# Less downtime and reduce maintenance cost

## Universal mold base for Series 2

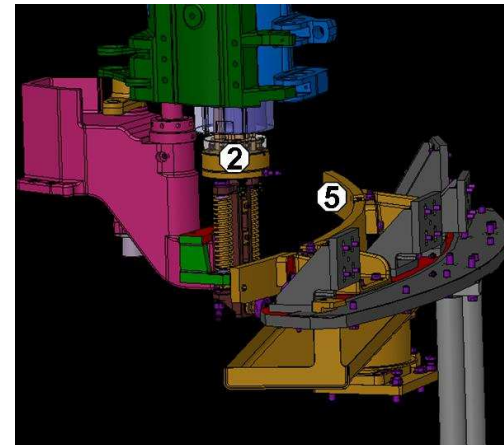
- Normally down base mold become (2) normally up base mold.
- Base mold down cam and base mold up cam are merged together: (5) only one cam
- Base mold stroke is reduced to 56mm. The stroke cam is bolted on its support, various possibility of adjustment will allow a perfect leveling.
